SECTION 00 91 01

ADDENDUM NO. 1

BUILDINGS 5 & 6 RENOVATIONS
 San Mateo County Community College District

CAÑADA COLLEGE
 4200 Farm Hill Boulevard
 Redwood City, CA 94061

PROJECT N
SCALE 1/8" = 1'-0"
THIRD FLOOR UPPER REFLECTED CEILING PLAN - ALTERNATE 9
4

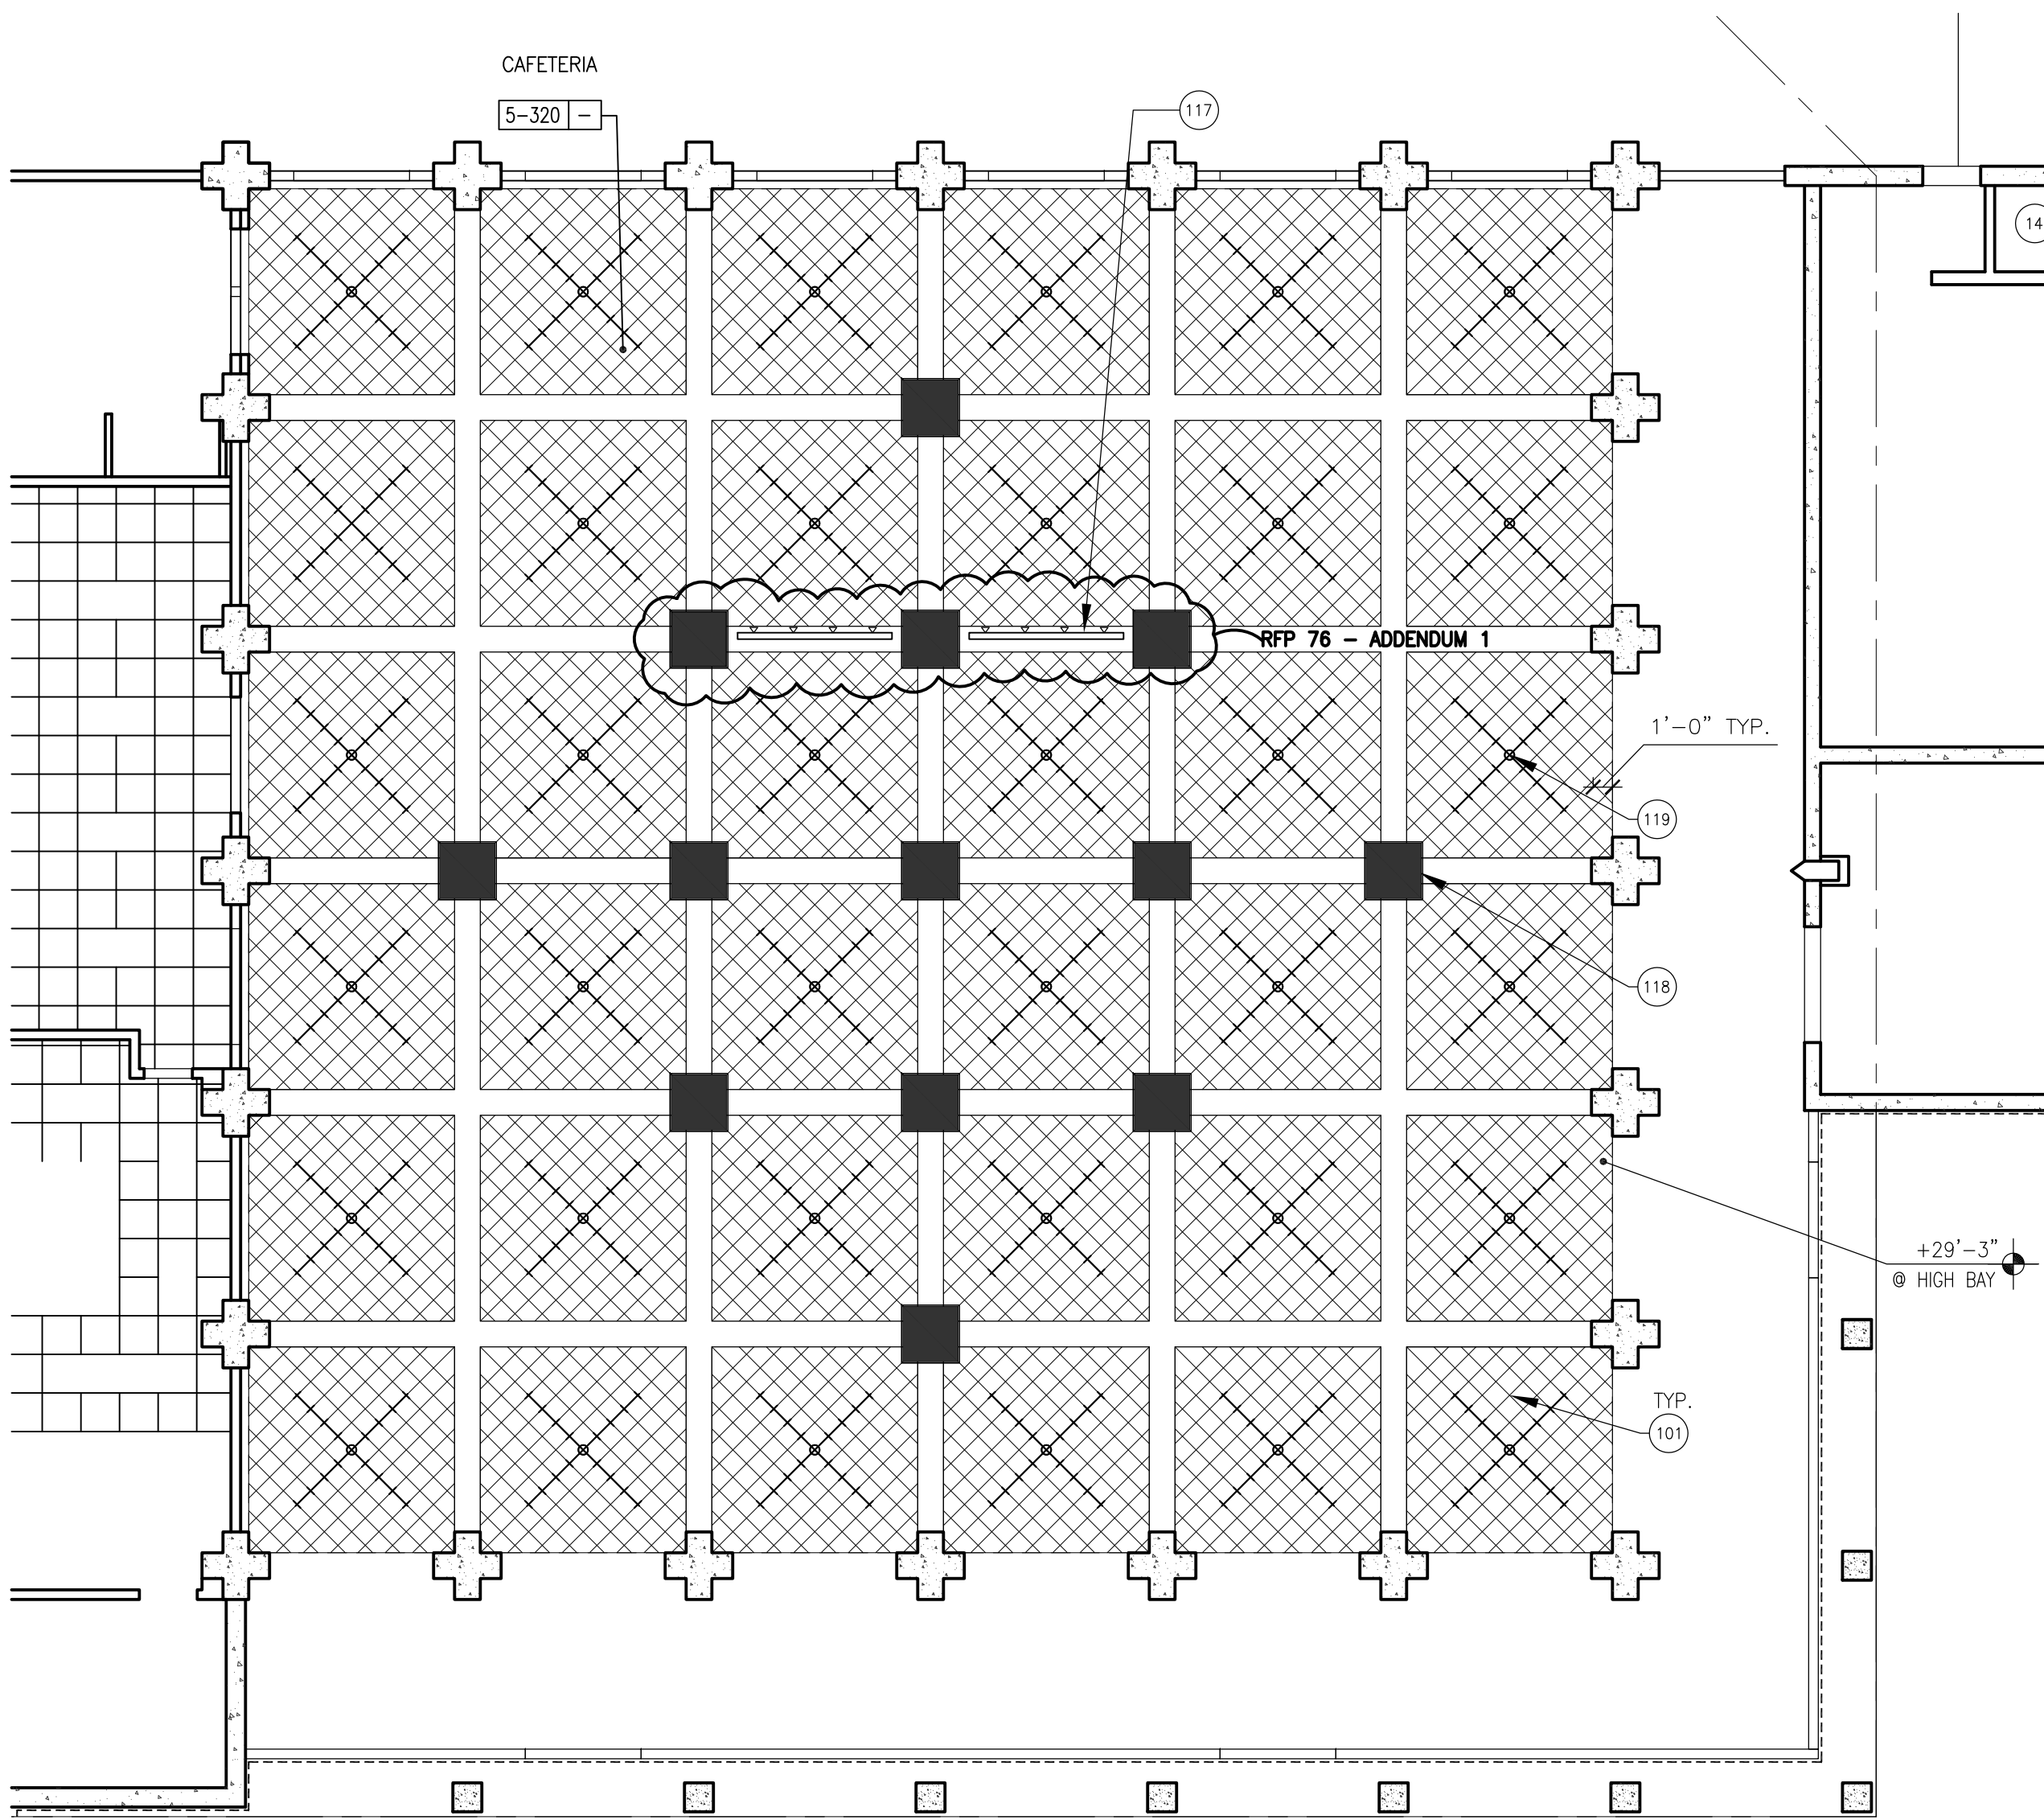
- 3. Drawing A3.34R – Third Floor Upper Reflected Ceiling Plan – Add Alternates.
 - A. Modified drawing as shown on attached revised Drawing A3.34R:
 - 1. Removed Add Alternate #10 from list of Add Alternates.

- 2. Replaced Stage Lighting Remote Lowering System with Fixed Stage Track Lighting for Detail 2, 3 and 4.
 - 3. Added Sheet Note 117 for Stage Lighting at bottom (e) coffered ceiling beam.

Date: 04/22/11
Scale: AS NOTED
Project Number: 07013
Drawing Number: A8.5R

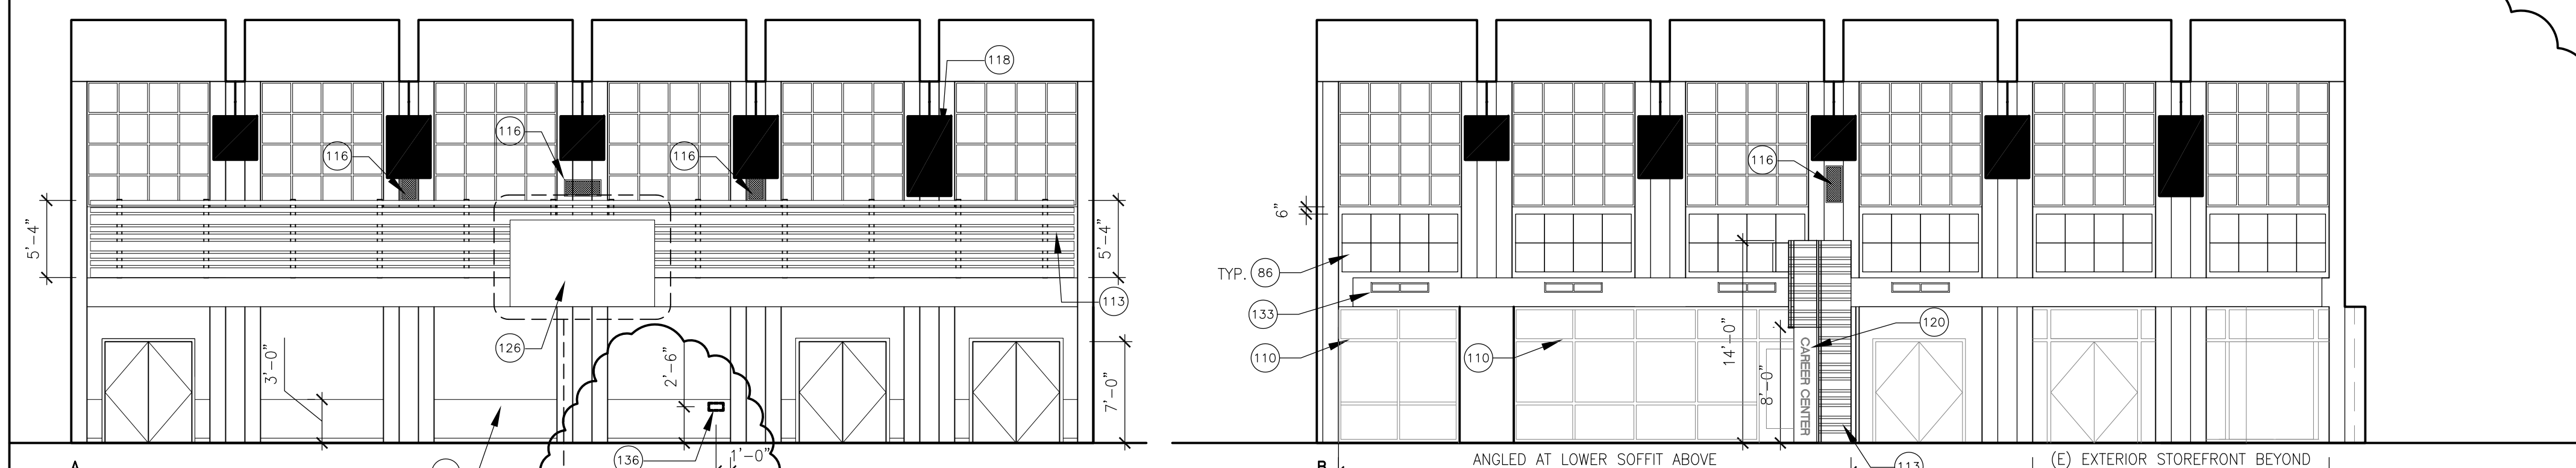
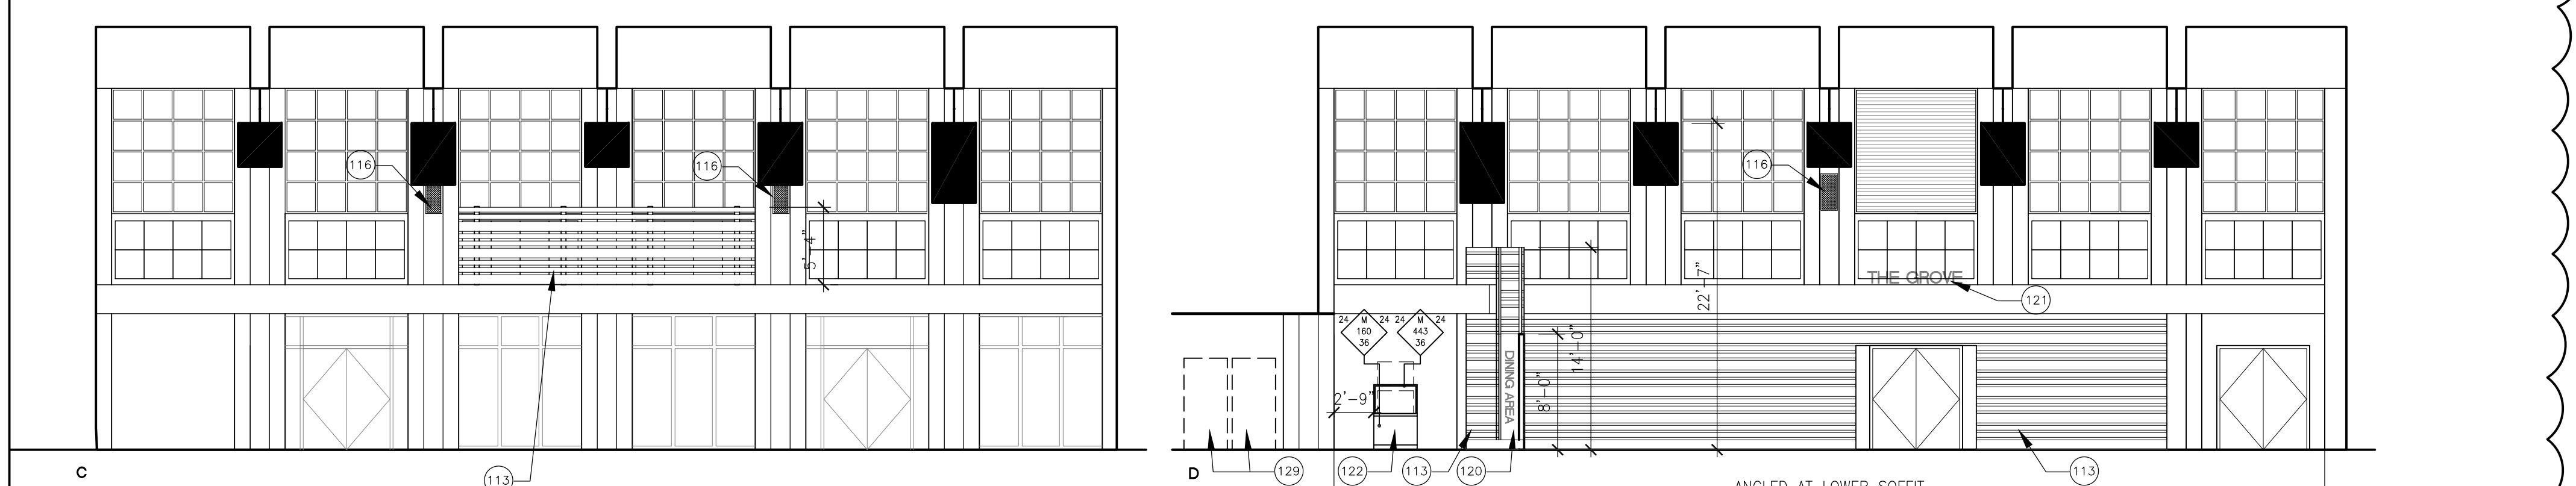
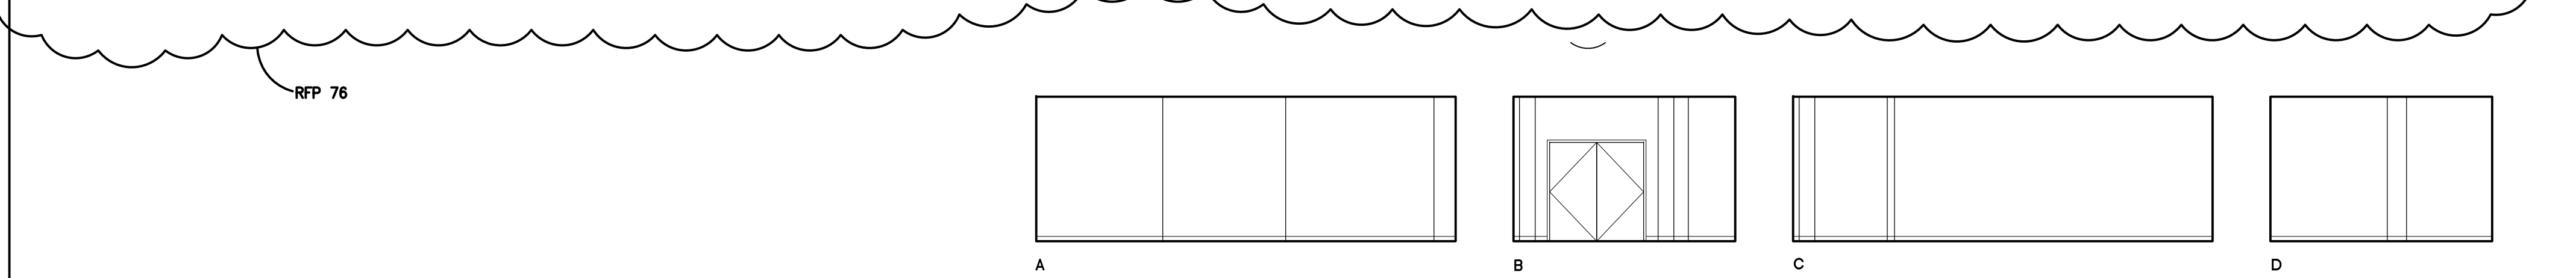
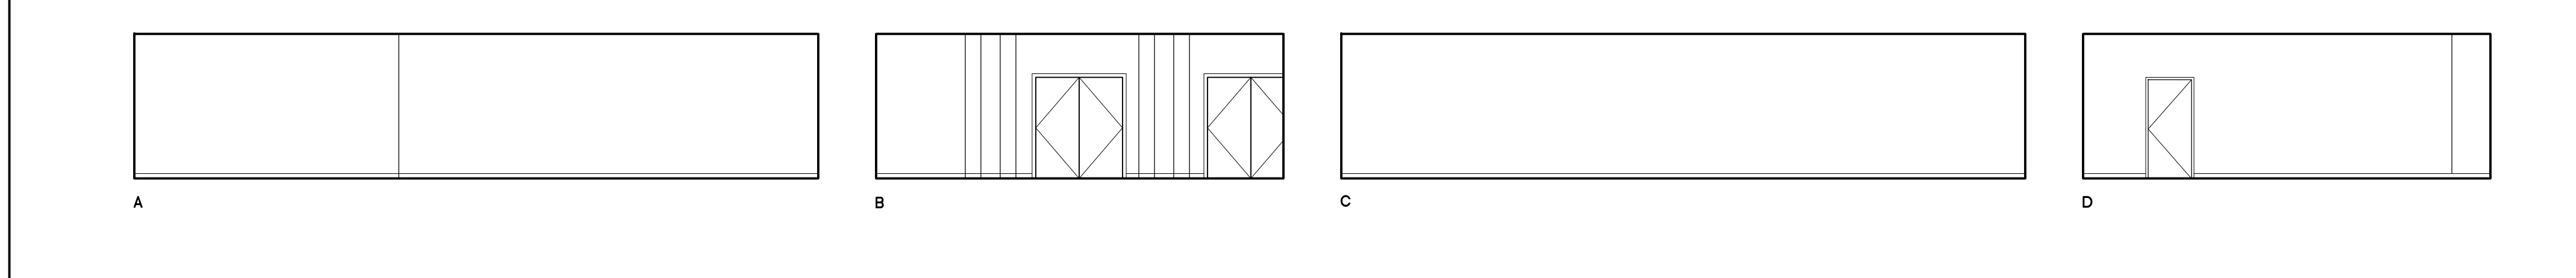
- 4. Drawing A8.5R – Third Floor Interior Elevations.
 - A. Modified drawing as shown on attached revised Drawing A8.5R:
 - 1. Added Sheet Note 116 for AV Speaker System.

- 2. Added AV Speaker system and Sheet Note 116 symbol at each speaker location in Cafeteria Room 5-320.
 - 3. Add Sheet Note 136 for AV Patch Panel
 - 4. Add location of AV Patch Panel on Interior Elevation 6A.

- 5. Delete Sheet Note 117.
- 5. Drawing A8.6R – Third Floor Interior Elevations - Alternates
 - A. Modified drawing as shown on attached revised Drawing A8.5R:
